Location: Main Street, Rathcoole, Co. Dublin

Planning Register Reference: SD22A/0323 (Ciaran Reilly)

RESPONSE TO REQUEST FOR FURTHER INFORMATION

Stage 1 Road Safety Audit

Figure 2.1 Configuration of Exit at Western Access to Main Street

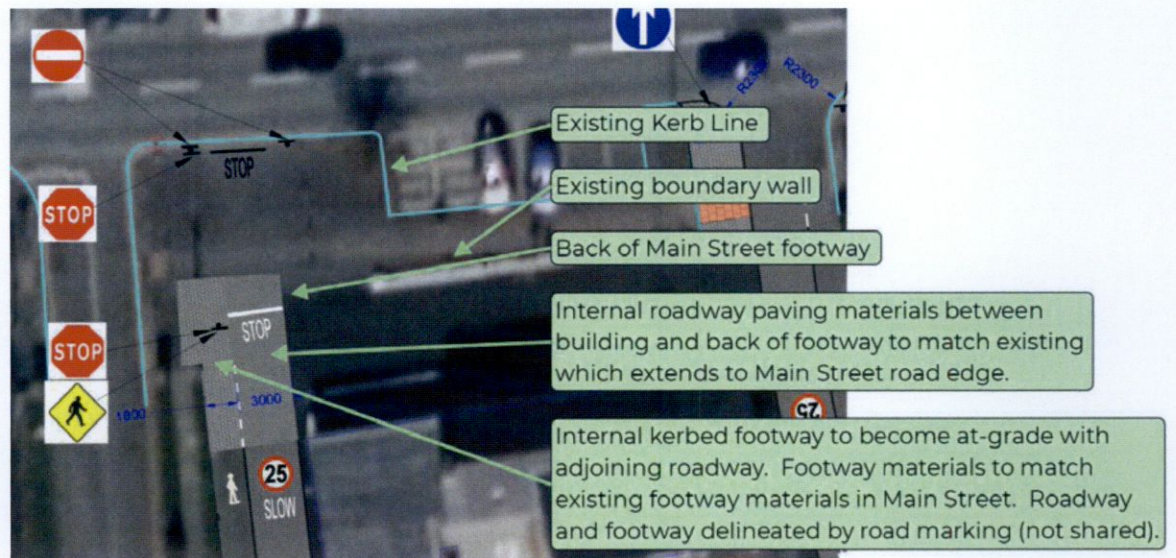
2.9 Item No. 3(A):

2.9.1 The revised entry/exit and circulation regime will mean that drivers exiting the site will cross the public footway at the existing western access point. The configuration of the existing access is such that the western boundary (party wall with Courthouse apartments) is set back from the back of the public footway by approximately 3.3m and from the edge of the pedestrian thoroughfare by approximately 4.7m as dimensioned in the following image.

2.9.2 Appropriate control measures will be in place where vehicles exiting the site and pedestrians are required to interact. It is proposed to provide a STOP line at the back of the footway within the boundary of the development site a second STOP line provided at the appropriate distance from the Main Street carriageway. This layout will be simple to understand, will highlight pedestrian priority along the footway and will allow for appropriate levels of visibility and inter-visibility for both pedestrians and motorists. The proposed exit layout includes for the reconfiguration of the building access ramp on the Main Street frontage of the existing building which will improve visibility between pedestrian users of the site and motorists exiting site.

2.9.3 The following **Figure 2.1** shows the proposed roads layout of the revised development overlain and geolocated on 2023 Google Earth imagery. **Figure 2.1** shows the suggested layout of road signing and road markings together with the proposed road surfacing between the building edge of the

existing protected structure. It is proposed that the internal footway will merge with the existing footway materials used in the main street and this area will be delineated from the roadway which will similarly be constructed using the matching roadway materials already in use in the main street.

Figure 2.2 Configuration of Entrance at Eastern Access to Main Street

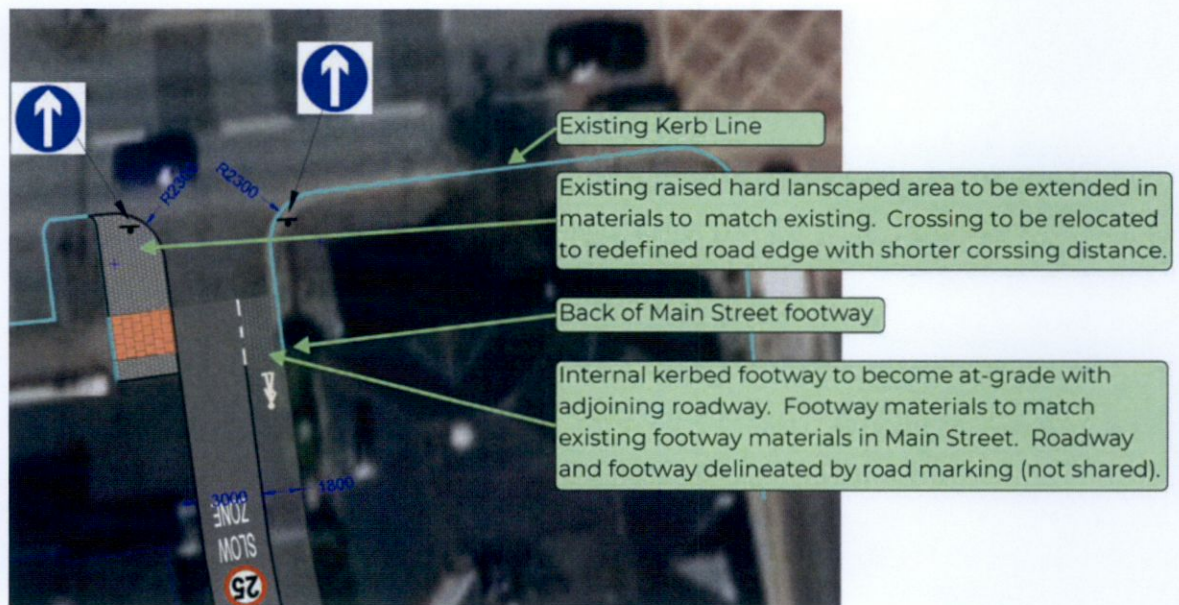
2.10 Item No. 3(B):

2.10.1 The proposed development access regime has been altered to make best use of the existing infrastructure to ensure satisfactory provision for pedestrian movement and efficient vehicle circulation. As directed in the RFI the internal access street and parking has been integrated with one carriageway provided which maximises the useable green space within the site. The layout will be intuitive to use for motorists entering from the Main Street since the eastern access is the more formalised of the two and is clearly delineated by raised kerbs.

2.10.2 As set out above the western access which is the dedicated egress will, through the use of complimentary materials, be integrated with the existing hard landscaping of the public realm and will provides generous inter-visibility for all users. It is proposed that the eastern access will be reduced in overall width in

line with the guidance of DMURS to reduce the overall crossing distance for passing pedestrians on the Main Street. The western side of the junction is proposed to be built out to increase the raised pedestrian area and it is proposed to relocate the existing crossing point. The following **Figure 2.2** shows the proposed roads layout of the revised development entrance overlain and geolocated on 2023 Google Earth imagery. **Figure 2.2** shows the suggested layout of road signing and road markings together with the proposed narrowing of the entrance and increase in the hard landscaping in the public realm. Similar to the exit treatment it is proposed that the internal footway will merge with the existing footway materials used in the main street and this area will be delineated from the roadway.

Figure 2.1 – Abrupt Footpath Commencement and Termination

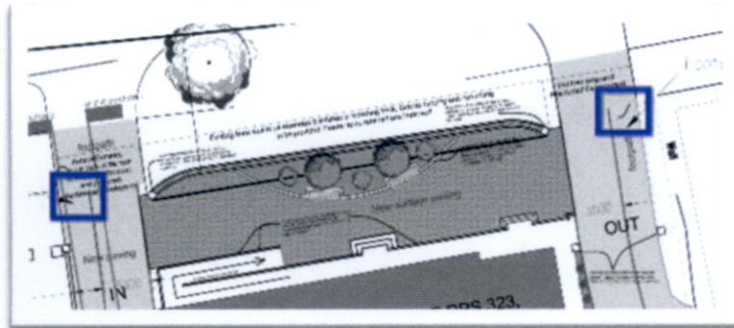
2.1 Problem: Connecting Public Footpath to Internal Footpath

Location: Site Entry & Exit Points onto Rathcoole Main Street

Vehicles are likely to over-run into the footpath areas which commence and cease abruptly at the site entry and exit points. This could lead to conflicts between vehicles and pedestrians.

To make the footpath commencement and termination points obvious to drivers, a high degree of contrast should be provided in the material finishes i.e., apply a light coloured finish to the footpaths and a contrasting dark coloured finish to the road pavement. The commencement and terminations of the footpaths should also be protected with a suitable traffic delineator.

2.1	Yes	Yes	High contrast materials will be used to distinguish footway from carriageway. The commencement/termination points will be protected with bollards similar to or matching those already in use in the receiving public streetscape.	<i>Comment noted with thanks</i>

Figure 2.2 – Direct Line of Sight & Shortest Exit Route to Main Street

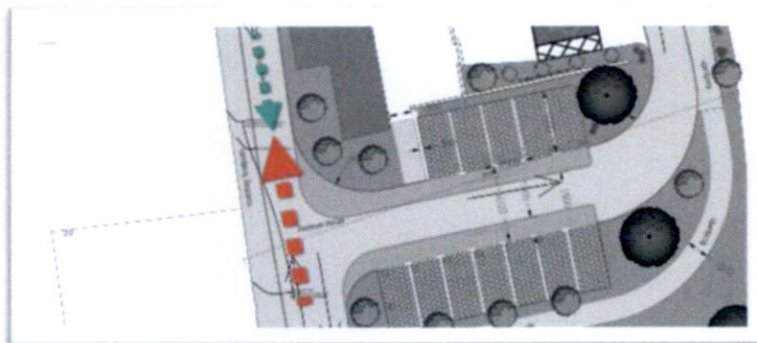
2.2 Problem: Wrong Way Driving in One Way Street

Location: One Way Entry Only Street

Drivers leaving the development are likely to take the shortest exit route, which will be afforded with a direct line of sight to Main Street. This could lead to opposition type conflicts, driver frustration or lengthy (dangerous) reversing manoeuvres.

Measures to appropriately remove or mitigate the risk of wrong way driving here should be developed by the Designer. Such measures might include switching the location of the entry and exit points (which would remove the opposition risk at source) or applying suitable signage and geometry adjustments to mitigate the risk.

2.2	Yes	Yes	It is proposed to swap the entry and exit points so that vehicles enter from Main Street via the more easterly access. Traffic will circulate in a clockwise direction as per typical convention (i.e. roundabouts). The inward circulation route will form an easily understood simple priority junction with the road leading to the exit. At detailed design state appropriate signing will be agreed with the Planning Authority and incorporated at the street interface and internally to ensure that the access regime is both intuitive and simple to follow.	<i>Comment noted with thanks</i>

Figure 2.3 – Transition Between Segregated (1) & Shared (2) Pedestrian Provision

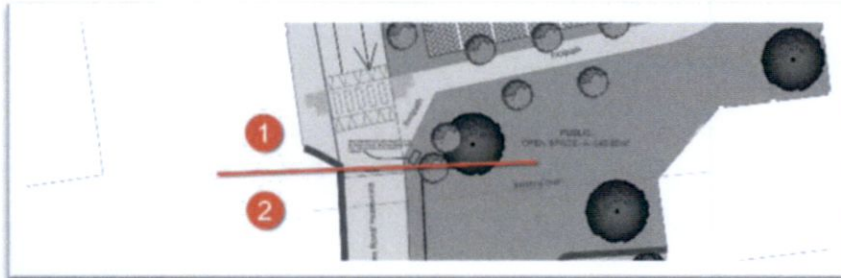
2.3 Problem: Changing Segregated to Shared Pedestrian Space

Location: Footpath Termination at top of Homezone Street

If not managed in a highly conspicuous manner, the change in pedestrian provision from segregated footpaths to sharing road space with vehicles could lead to conflicts between pedestrians and vehicles in the Homezone street.

The Designer should develop appropriate measures which might afford priority and safety to pedestrians within the Homezone street. Such measures might include the provision of a conspicuous gateway at the start of the Homezone, a change in material finishes and / or the setting aside of a pedestrian refuge area in front of the houses which could be marked with a flat channel.

2.3	Yes	Yes	A proposed ramp and pedestrian crossing provide a suitable gateway entry to the homezone which will also include appropriate 'Homezone' signing facing entering vehicles. The rear of the homezone signs will be used to reinforce the one-way exit system and the prohibition on the internal right turn. Road markings and directional arrows will be used to highlight the one way system to users of the site including those parking. Contrasting materials will be used in the homezone to distinguish the area from the circulation route around the existing building facing Main Street. The eastern side of the homezone street will be highlighted for pedestrian use through the incorporation of a dividing channel. This is a recognised technique for encouraging	<i>Comment noted with thanks</i>
